Response to Submissions Report

Alterations and Additions to Parramatta West Public School
Auburn & Young Streets, Parramatta

11 October 2019

Figure 1: Tuflow Model Results from PMF (Source: Lyall & Associates)

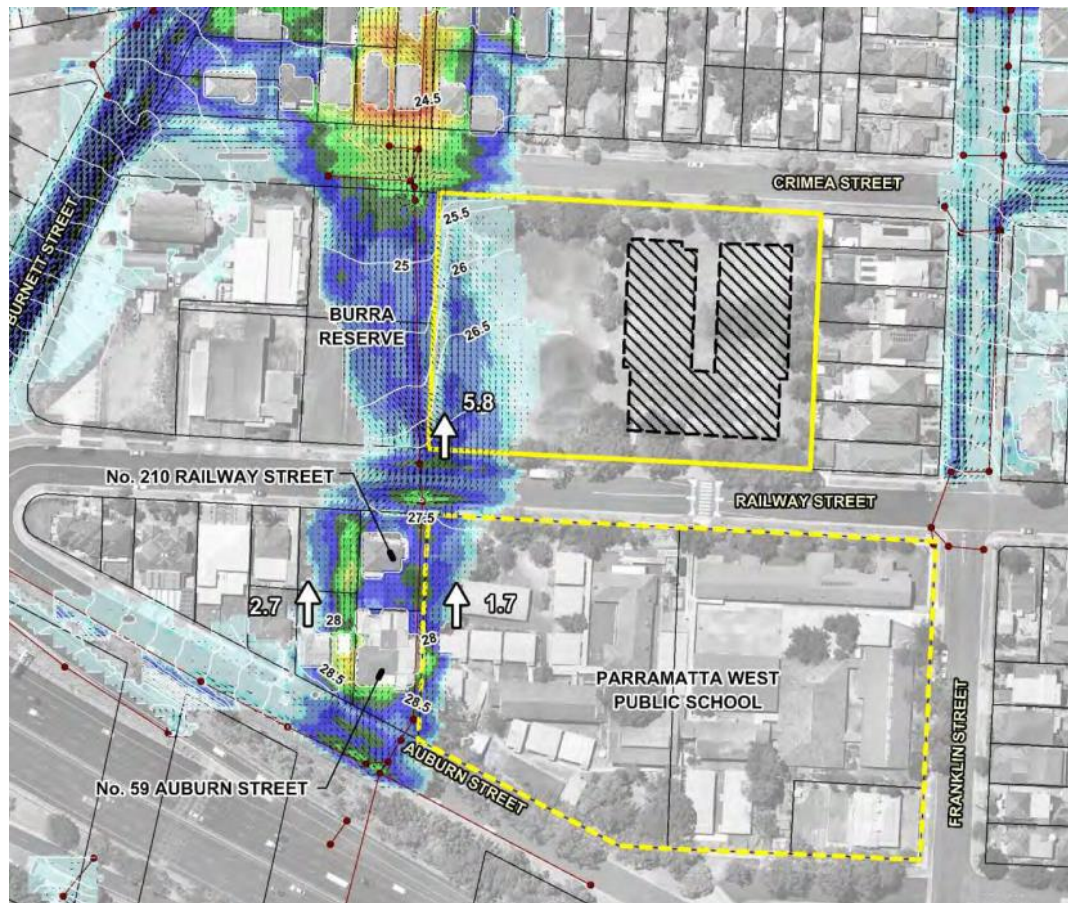
1d	Siting the proposed building along the western boundary of the existing oval / open space would increase the distance between the school and the adjoining residences on Franklin Street (east). This would assist in addressing the potential adverse environmental amenity impacts on the neighbouring residents.	The western portion of the north site includes an area that is impacted by localised overland flow / flooding as detailed in the Flooding Assessment provided in Appendix S of the EIS. An extract of the Probable Maximum Flood (PMF) mapping (Figure 7 of the flooding assessment) is included below as Figure 1. As this portion

No	Submission Detail	Response
		of the site is potentially not safe for children, and unsuitable for building construction, this option was not considered viable. The location to the east provided: • A safer option for children as it was located out of the flood area, • A more appropriate link to the existing school site in terms of safety and efficiency for the school and students including the pedestrian crossing, • A better connection of the permanent school buildings, • A linkage between the open space play areas, and • A buffer between the dwellings and the play area, which would assist in screening the playground noise and providing an increased level of privacy to the residents. Refer to sketch in Figure 2 below.
1e	The Department requires that an alternate design option of locating the proposed new school building along the western boundary of the existing oval / open space, be analysed. The RTS should include satisfactory justification as to why this section of the site is not suitable for locating the building.	As indicated in response to point 1d above, this location was not considered a viable option for the following reasons: • Potential flooding impacts; • Lack of connection to existing school buildings; • Fragmentation of open / green spaces; • The western portion of the site does not coordinate with the current safe and efficient road crossing between the north and south sites; and • It does not provide residents to the east with any acoustic buffering to playground noise.

Figure 3: Annotated extract of proposed play space plan – South Site

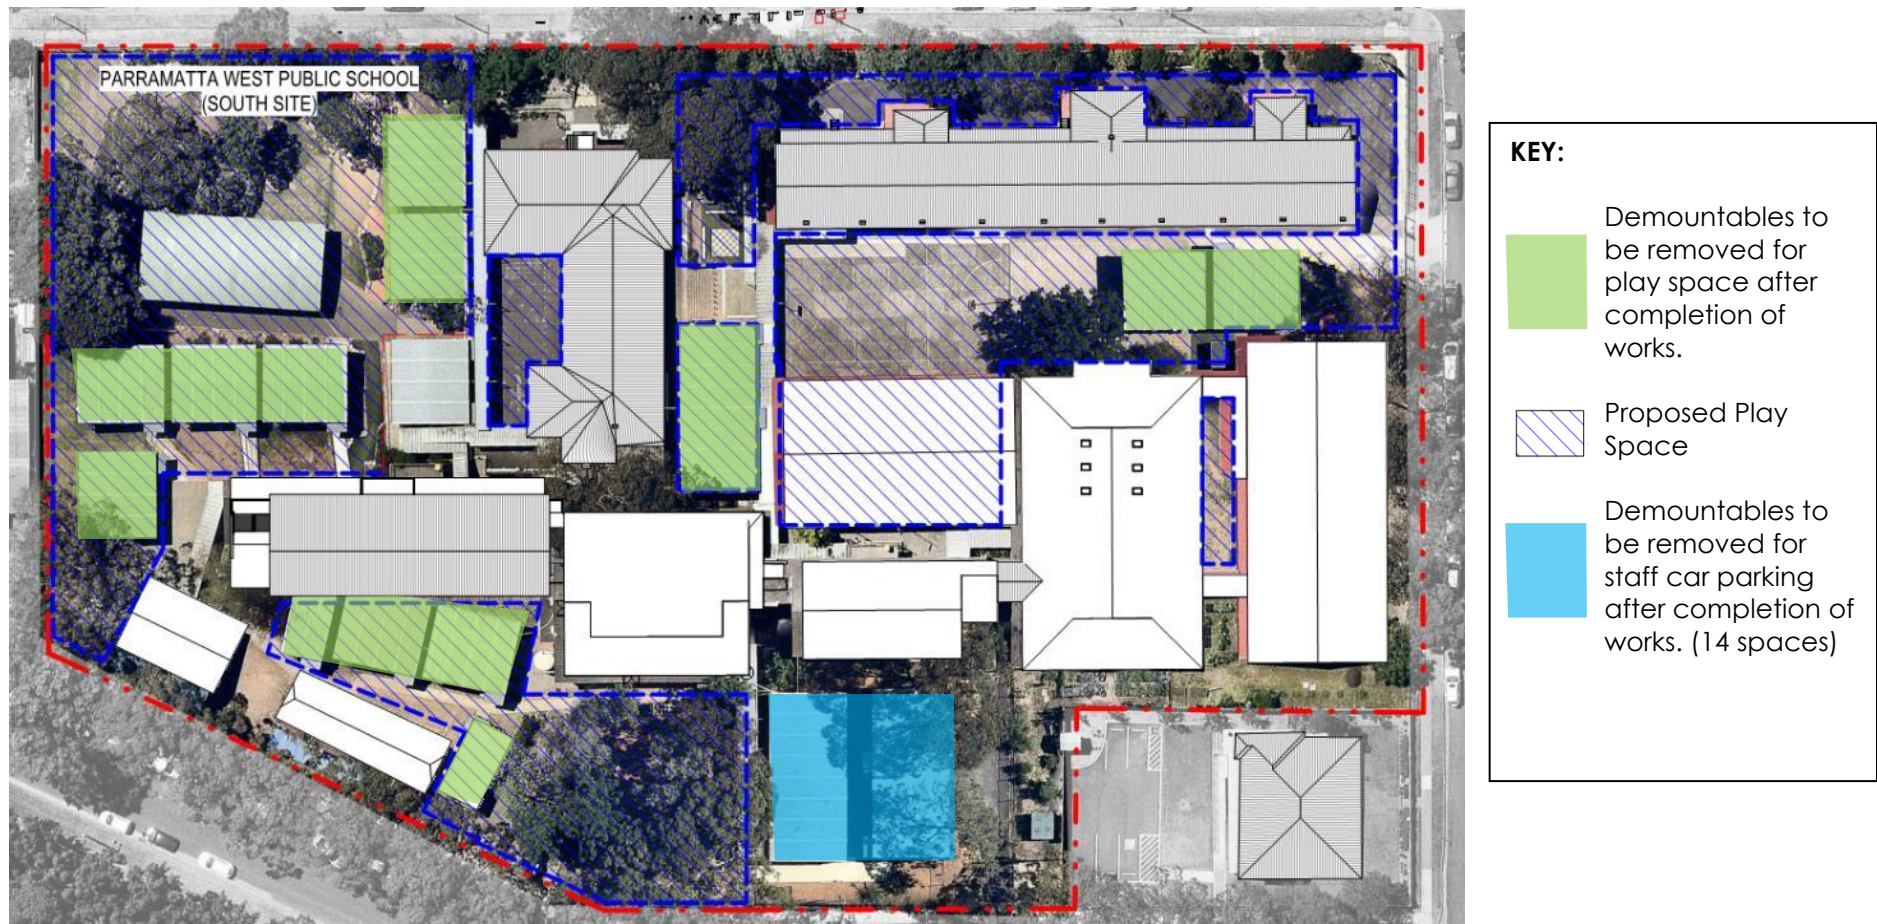
1u	The submitted site plan and aerial photographs identify a car parking area on the southern section of the site. This does not represent the current scenario where demountable buildings occupy the former staff car-parking area. The Department	An amended site plan with aerial photograph has been prepared and is included in Appendix H. Figure 3 (and the plans in Appendix H) identifies the demountable classrooms that are to be removed following the occupation of

No	Submission Detail	Response
	requires that amended plans be submitted to include accurate details of the proposed layout of the site. An aerial photograph should be provided identifying all existing demountable buildings that are proposed to be removed (under separate complying development applications).	the new buildings on the north site. A combination of play space and car park (14 spaces) will be re-established on the site following the removal of the demountables. It should be noted that the catchment for Parramatta West Public school has changed – refer to extract of plan included in Figure 6 below. This will have flow on effects and potentially reduce the increase in numbers of students attending the school.
1v	The EIS does not include details of specific mitigation and management measures that would be implemented to protect the amenity of the students during construction works within the existing school on the southern site.	A preliminary Site / Construction management plan has been prepared to identify the mitigation measures that will be implemented to maintain student amenity during construction works. The preliminary plan recommends the use of the following mitigation measures: • Diversion of pedestrians by traffic controllers with appropriate fencing and hoarding; • Heavy deliveries should occur outside of peak school traffic hours; and • Location of the main access point for construction will be from Crimea Street to reduce the potential for conflicts. Construction works can be managed in accordance with the relevant EPA guidelines to ensure potential noise and dust impacts are managed appropriately. Further, play times will be staggered during construction works to ensure sufficient play space is available. Mitigation strategies will be confirmed following SSDA approval, with regard to the conditions of development consent and with input from the Head Contractor.

Figure 8: Tree Canopy Calculations for North Site (Source: Conrad Gargett)

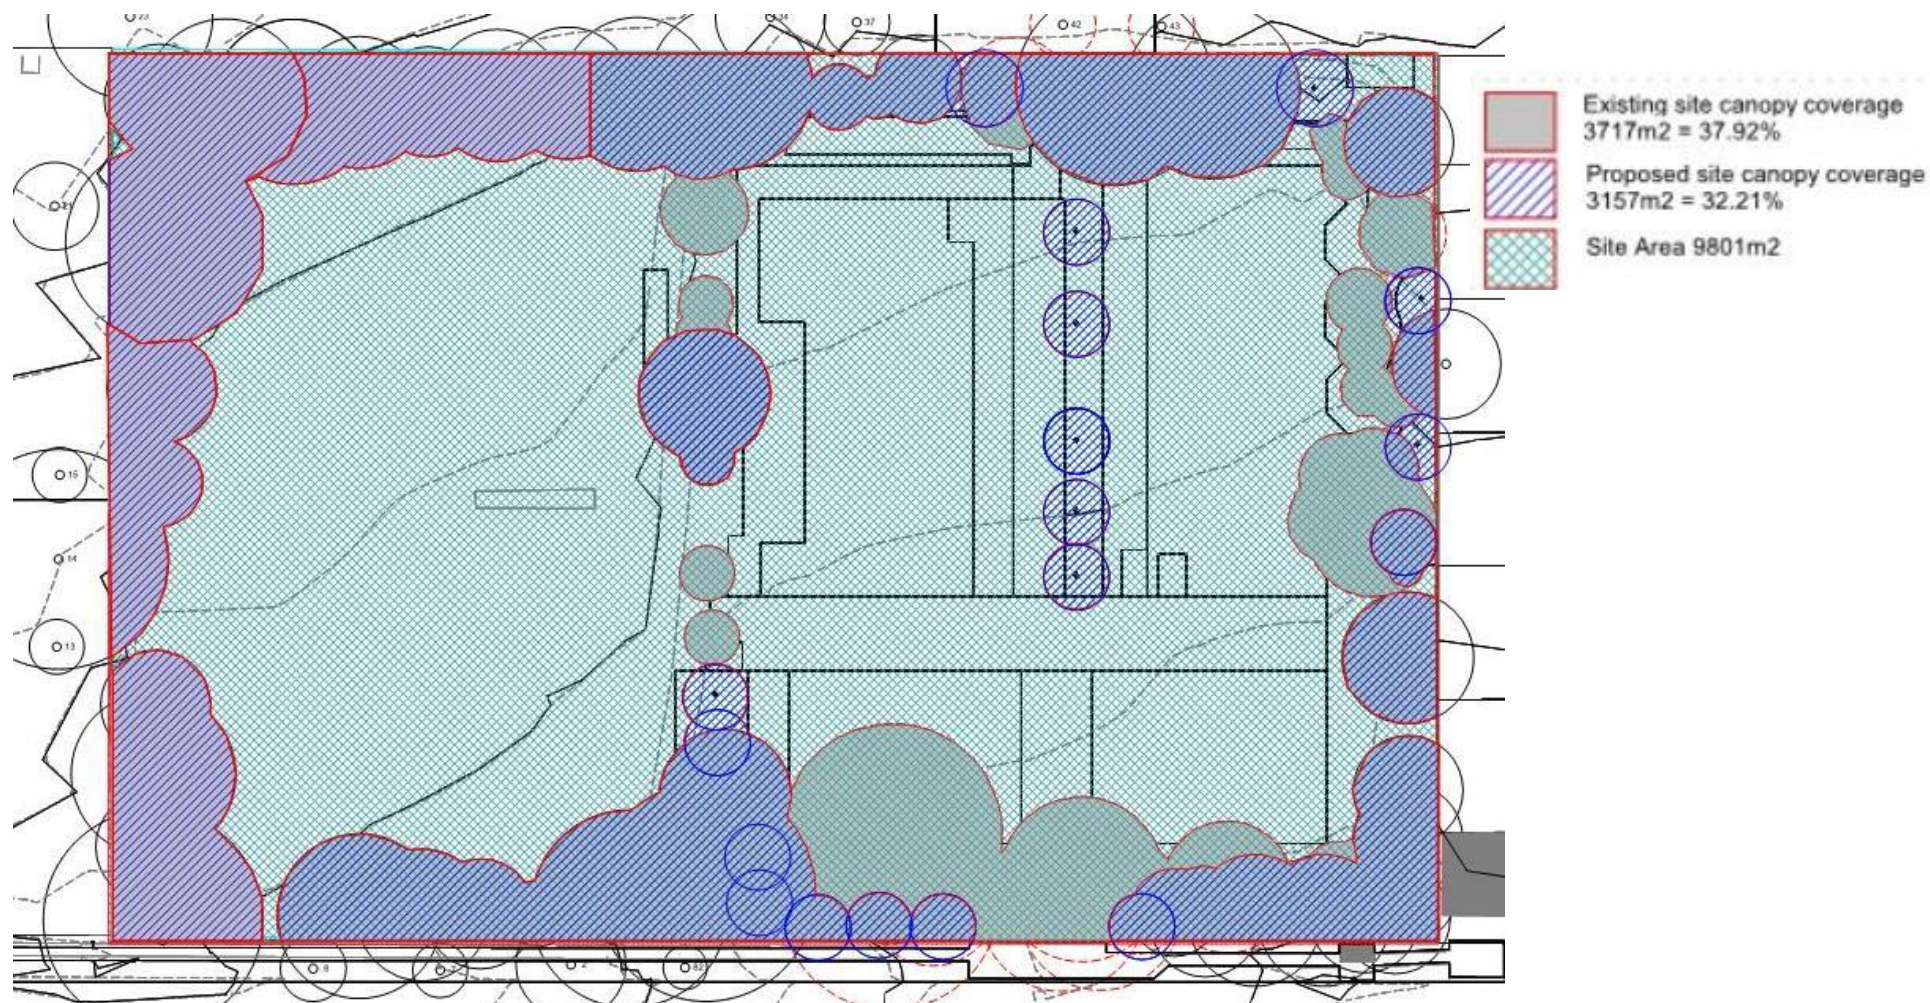
7k	OEH also recommends that the NSW and ACT Governments Regional Climate Modelling (NARciM) climate change projections developed for the Sydney Metropolitan area used to inform the building design and asset life of the project. These include over 100 climate variables, including temperature, rainfall, hot days and cold nights, severe Forest Fire Danger Index (FFDI) and are publicly	Noted. Whilst no formal assessment has been conducted, the building has been designed with best practice initiatives in mind to mitigate the risk of climate change. These include passive design measures so the spaces can be used under hot and cold extremes, selection of mechanical plant to manage extreme temperatures, careful selection of landscaping, roof design to

Figure 9: Section of North Elevation

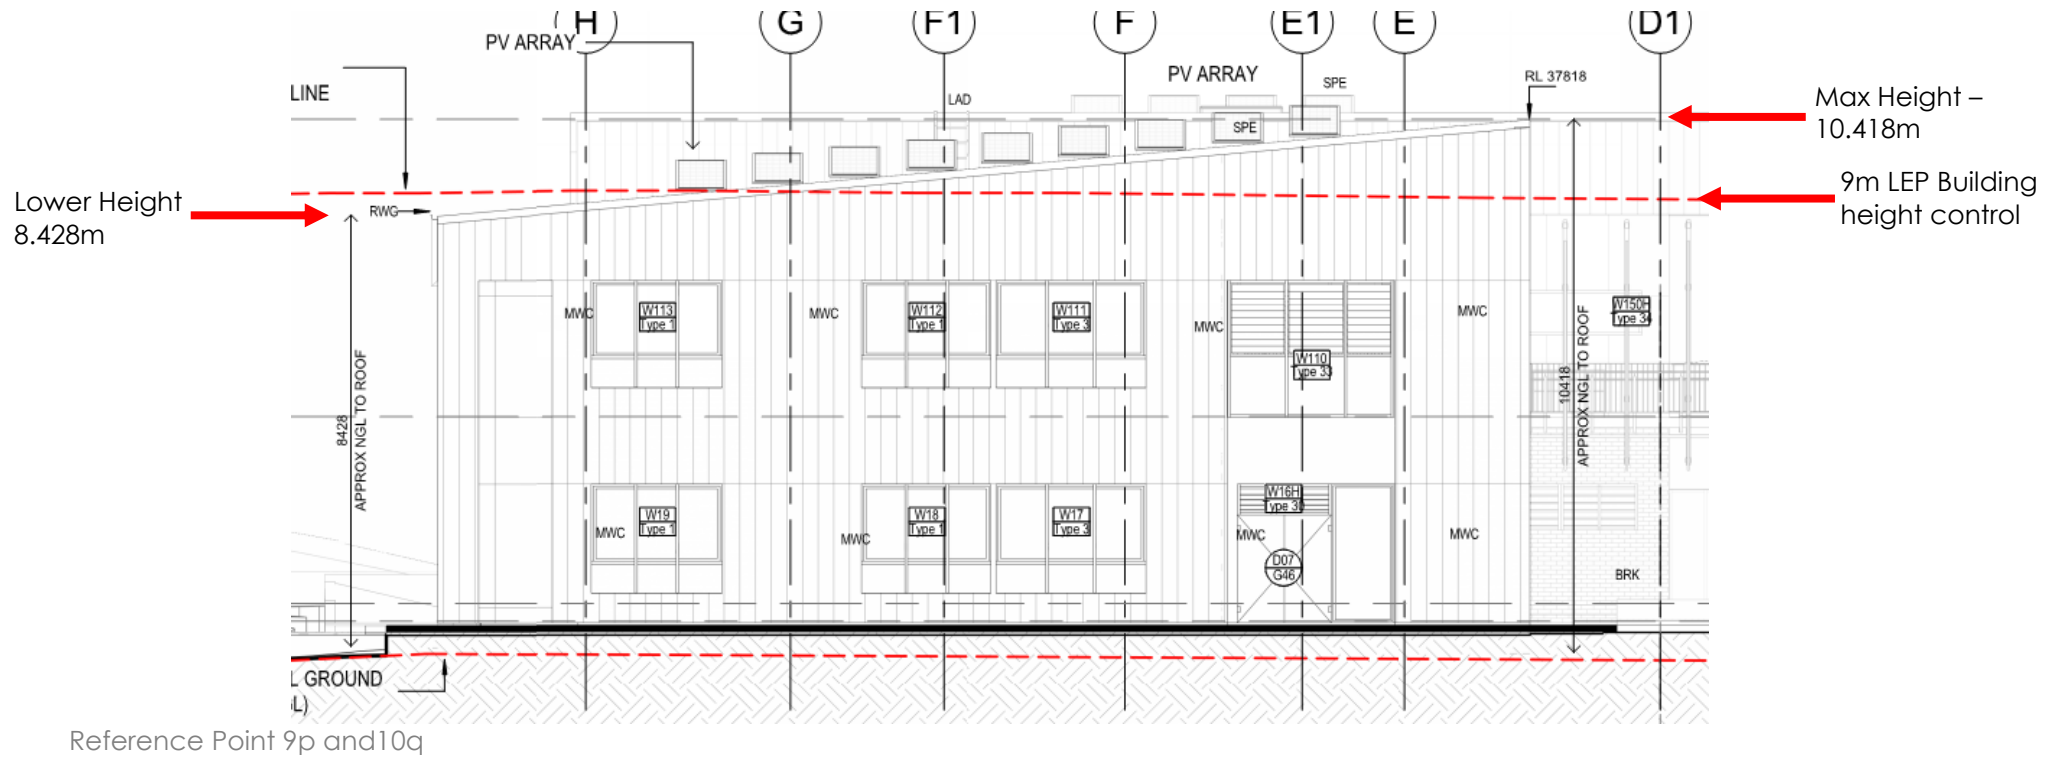
9ag	Ideally, any redesign of the Parramatta West Public School should to seek to retain the active recreation open space for use by the school students but also the growing local community through supportive shared use arrangements.	Noted, as outlined above, the proposal will ensure suitable areas are available to facilitate active recreation on-site. Further, the proposal will not alter the school's current arrangements for managing community uses on-site after school hours (i.e. formal requests will still need to be lodged with the school to facilitate out of hours use by the community).
